TOWN OF PALM BEACH
Planning, Zoning & Building Department
360 South County Road
Palm Beach, FL 33480
www.townofpalmbeach.com

PZ&B Staff Combination Memorandum: Landmarks Preservation Commission and Town Council

SUBJECT: COA-24-0018 (ZON-24-0043) 100, 101, 102, and 103 FOUR ARTS
PLZ—SOCIETY OF THE FOUR ARTS

MEETING: NOVEMBER 13, 2024, TC
NOVEMBER 20, 2024, LPC

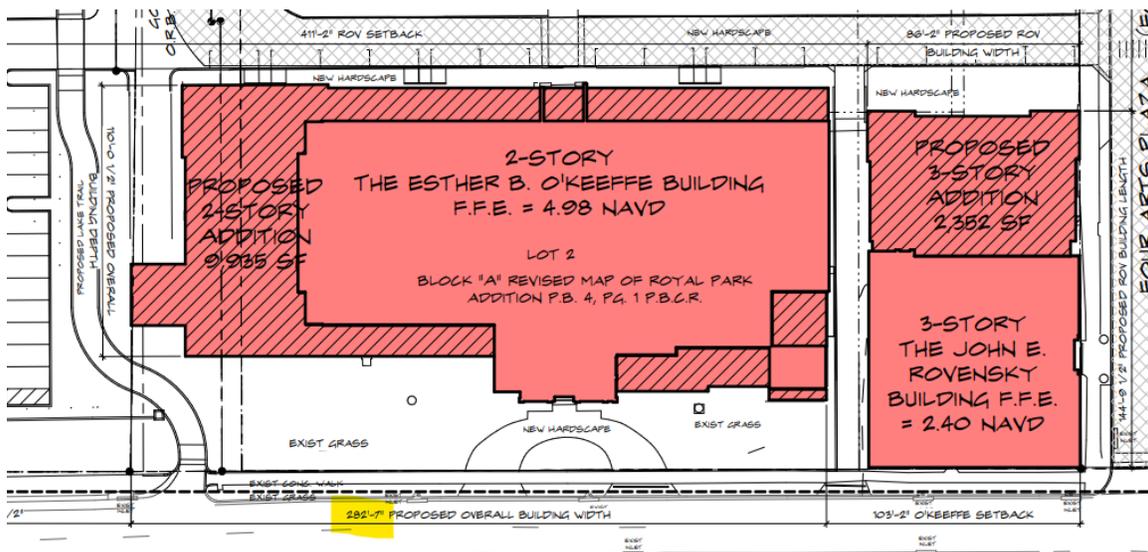
The existing arts campus is a 7.6 acres waterfront site and situated on the southeast intersection of Royal Palm Way and Cocoanut Row a prominent location along one of the main gateways to the Town of Palm Beach. As discussed in the history section of this memorandum, the site has an east and west campus bifurcated by the Four Arts Plaza right-of-way. The east campus contains the Dixon Education Building, the King Library, and the Phillip Hulitar Sculpture and Botanical Garden. The west campus contains the Rovensky Building and the Esther B. O’Keeffe Gallery Building.

Three buildings (King Library, Rovensky Building, and Esther B. O’Keeffe Gallery Building) and two Volk-designed piers at the entrance of Four Arts Plaza were landmarked. Of the three landmarked buildings, the proposal impacts Rovensky and O’Keeffe Gallery buildings. Improvements are also proposed to the non-landmarked shade structure. The application includes substantial demolitions, renovations, and additions that will provide a significant increase in square footage. New one- and two-story additions are proposed for the existing two-story theater building (O’Keeffe) totaling 9,935 SF in floor area, and a new three-story addition is proposed adjacent to the existing three-story administrative building (Rovensky) totaling 10,738 SF of new floor area. In all, 16,747 SF of new footprints to the campus will occur bringing the total lot coverage of the campus up from 15.3% (46,678 SF) to 20.2% (61,699 SF), which is still 10% below the maximum lot coverage allowed of 30% (91,476 SF).

Additionally, the Lake Trail right-of-way bifurcates the west campus. The subject application seeks to abandon this easement to reconfigure the pedestrian path. The formal abandonment and new dedication will be processed separately, however, is it recommended that it be discussed during the site plan review since it impacts the proposed configuration of the site (and possibly additional parking space loss). Also, the applicant has provided a preliminary master sign program to provide a comprehensive way finding signage program apt for a campus-like setting. More specificity and design details regarding the proposed signage sizes, fonts, materials, and colors is needed to render a final decision. Therefore, it is recommended that a more detailed master sign program return to LPC at a later date for review.

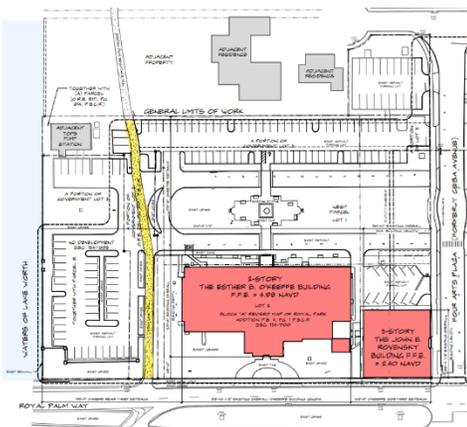
The museum square footage will decrease slightly. The theater capacity will also be reduced to 656 seats. Therefore, the required parking is summarized below:

- Theater: 656 seats (1 parking space per 4 seats), requires 164 parking spaces
- Professional Office: 31,526 square feet (1 parking space per 250 square feet), requires 126 parking spaces
- Museum: 5,186 square feet (1 parking space per 500 square feet), requires 10 parking spaces
- Library: 7,800 square feet (1 parking space per 500 square feet), requires 16 parking spaces
- **Total Required Parking: 316 spaces**

The variance request currently seeks to reduce the parking to 233 spaces, representing a reduction of 83 spaces (26%). A parking study by Kimley Horn was submitted that presents parking demand for visitors and employees. The study concludes that *“Accounting for variations in time-of-day demand for uses on site, the peak parking needs for the campus are anticipated to be approximately 232 spaces during the weekday peak period in which the theater is in use. Therefore, the parking needs for the site are anticipated to be met.”*

The Town’s code does not offer alternate parking requirements based on parking demand calculations.

Proposed Trail

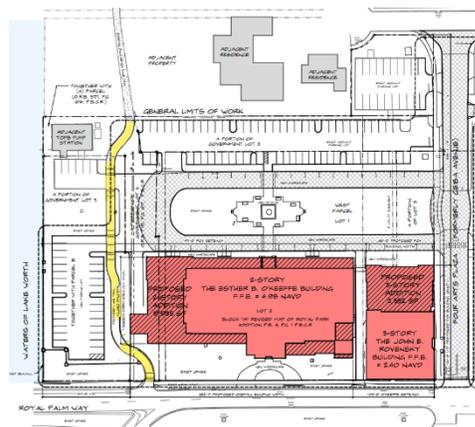
As previously mentioned, the existing Lake Trail right-of-way traverses the west campus towards the western side of the site. To accommodate the proposed additions to the O’Keeffe building, the application seeks to abandon this easement to reconfigure the pedestrian path slightly to the west. The formal abandonment and new dedication will be processed separately, however, is it recommended that it be discussed during the site plan review since it impacts the proposed configuration of the site (and possibly additional parking space loss). A general consensus for the direction of the application as it pertains to the relocation of the Lake Trail would be appropriate.
